MONTGOMERY COUNTY PLANNING DEPARTMENT
 THE MARYLAND-NATIONAL CAPITAL PARK AND PLANNING COMMISSION

MEMORANDUM

REVIEW TYPE: Preliminary Plan Review

PROJECT NAME: Randolph Plaza

RANDOLPH PLAZA (120070140)

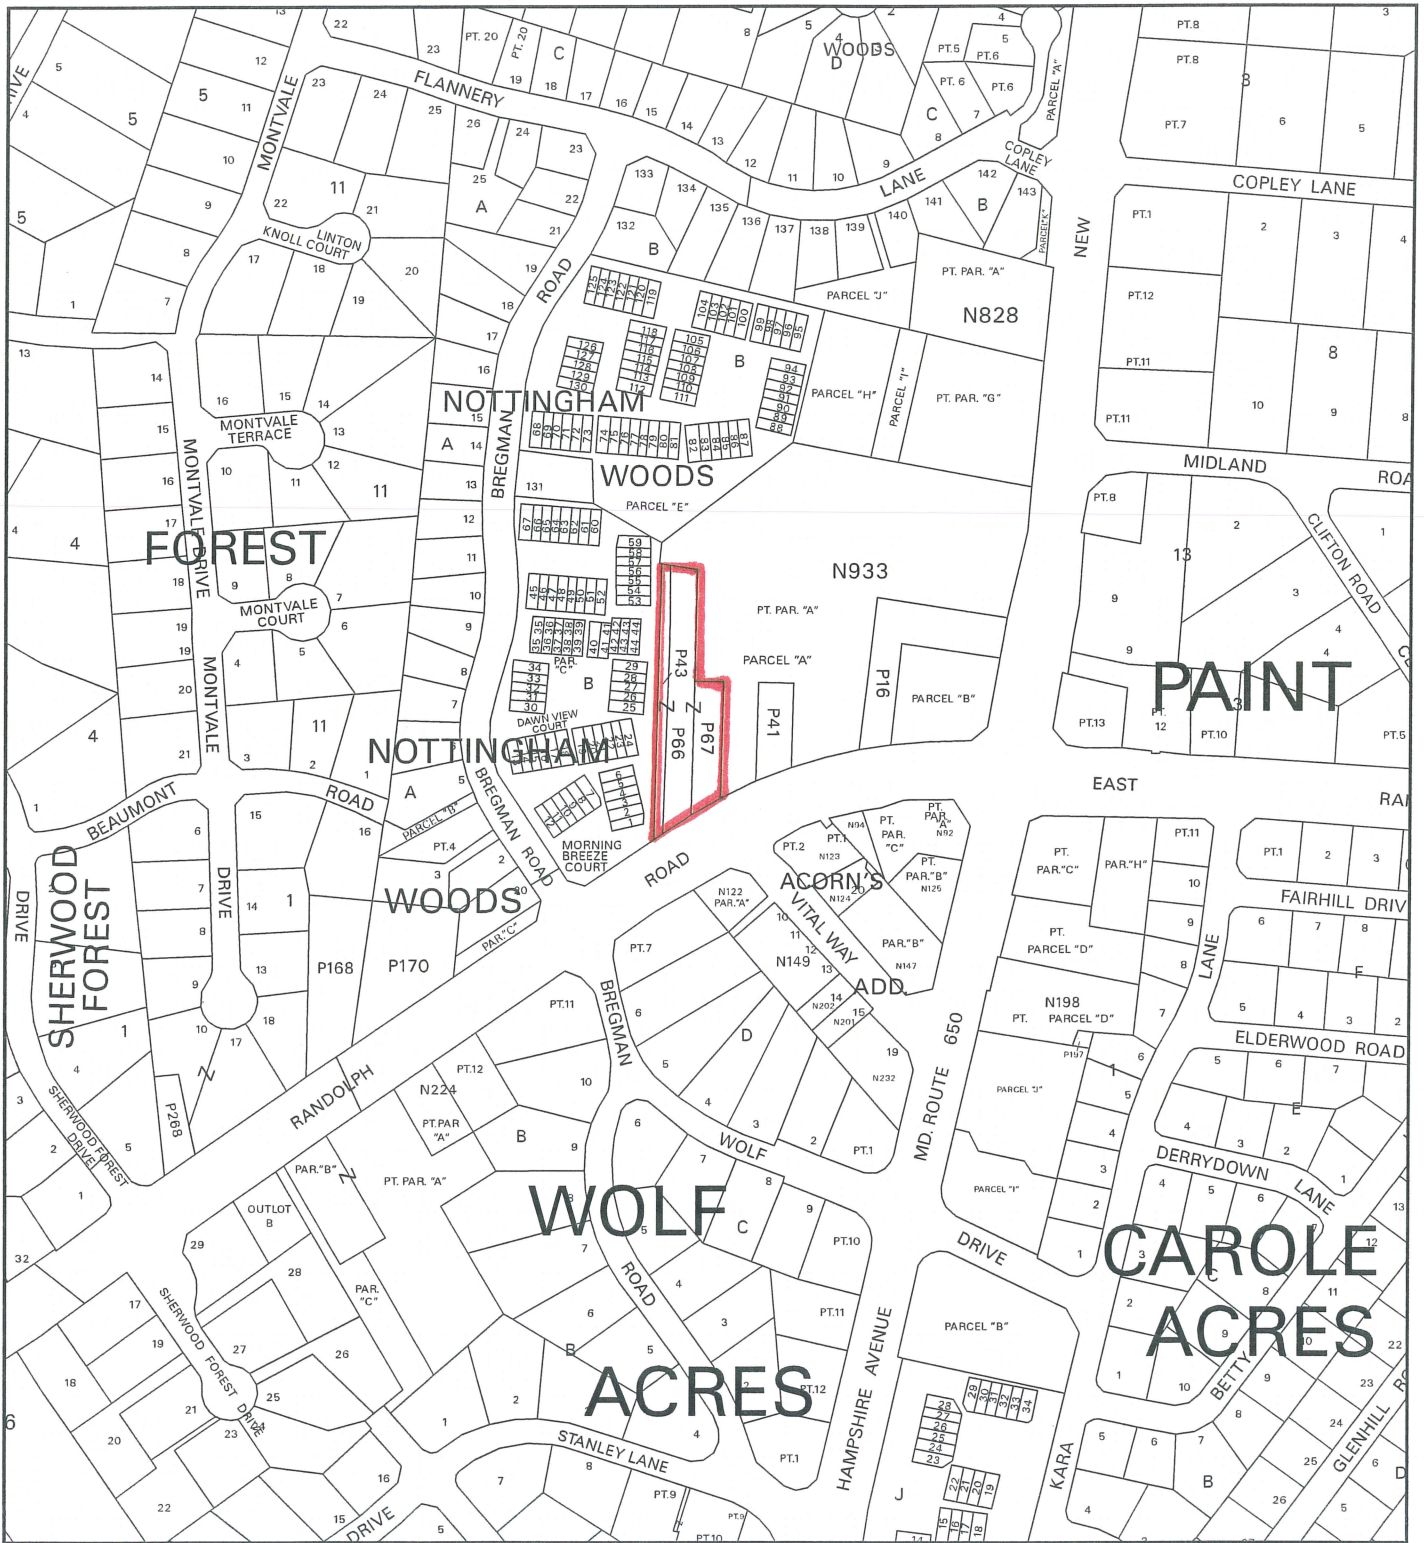
1. Show/label all existing planimetric and topographic details specifically driveway opposite the site as well as correct location of existing rights of way on both sides and easements on the preliminary plan.

2. Necessary dedication for Randolph Road in accordance with the Master Plan.
3. Grant necessary slope and drainage easements. Slope easements are to be determined by study or set at the building restriction line.

5. Use DPWT standard driveway detail and perform the necessary adjustments.
6. The sight distances study has **not** been accepted. Prior to approval of the record plat by DPS, the applicant's engineer will need to submit a distances certification reflect minimum of four hundred and seventy five (475) feet of sight distance in each direction.

8. The parking layout plan will be reviewed by the Department of Permitting Services at the site plan or building permit stage, whichever comes first. To facilitate their review, that plan should delineate and dimension the proposed on-site travel lanes, parking spaces, curb radii, handicap parking spaces and access facilities, and sidewalks. The applicant may wish to contact Ms. Sarah Navid of that Department at (240) 777-6320 to discuss the parking lot design.

10. Curb radii for intersection type driveways should be sufficient to accommodate the turning movements of the largest vehicle expected to frequent the site. However Driveways curb returns should not cross the property lines. Also provide proper spacing between the driveways curb returns and public utilities features.

11. The parking lot travel lanes are to be designed to allow a WB-50 truck to circulate without crossing the centerline nor the curblines.
12. The applicant needs to submit a truck circulation plan for review by the M-NCPPC and MCDPS. This plan should delineate the proposed movements on-site between the anticipated access locations, the proposed truck loading spaces, and the proposed dumpsters. The truck circulation pattern and loading position should be designed for counter-clockwise entry and for a left-side backing maneuver. Passenger vehicle travel ways should be separated from the expected truck patterns and storage areas. The applicant may also need to provide documentation of their proposed delivery schedules.

13. Truck loading space requirements to be determined in accordance with the County's "Off-Street Loading Space" policy.
14. On the site plan, delineate the location and dimensions of the proposed truck loading and/or dumpster spaces.

15. Provide on-site handicap access facilities, parking spaces, ramps, etc. in accordance with the Americans With Disabilities Act.
16. Where perpendicular parking spaces border a sidewalk, a two (2) foot vehicle overhang is

- assumed. The applicant should either provide a seven (7) foot wide sidewalk or wheelstops within those parking spaces.
17. For any parking facility containing more than fifty (50) parking spaces, the applicant needs to furnish bicycle parking facilities as required Section 59 E-2.3 of the Montgomery County Code. Accordingly, the applicant should provide either bike lockers or inverted "U" type bike racks.
